# Access Compliance Report

## Public Rights-of-Way

Intersection ID: 13743	Main Street: DR_CARVER_RD	Cross Street: WEST_BV	Location: SW
ADA ID: F044B31C34B1	Ramp Type: ParaDiag	Initial Pass/Fail: Fail	Overall Compliance: No
Codes/Mitigation Info/Possible Solution		Field Measurements/Component Compliance	
Severity Score: 22.5

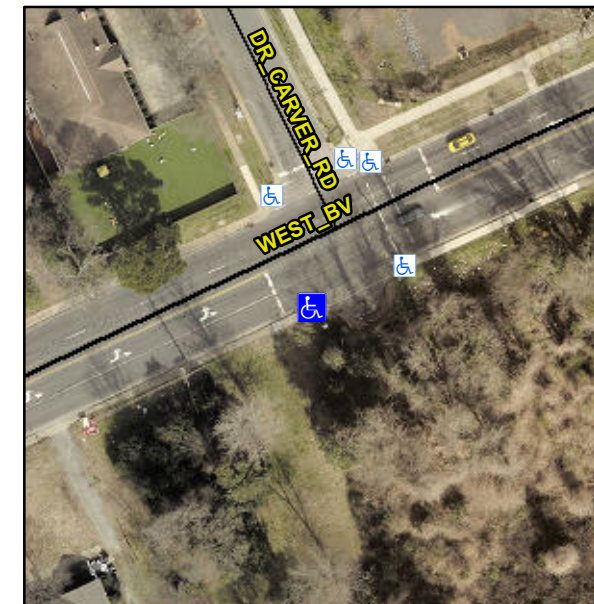
**DWS NAILS EXPOSED, LT RP < 5%**

**R304.5.1, R304.5.3, R304.3.2**

**Remove & Replace Curb Ramp With Two New Directional Ramps or Equivalent.**
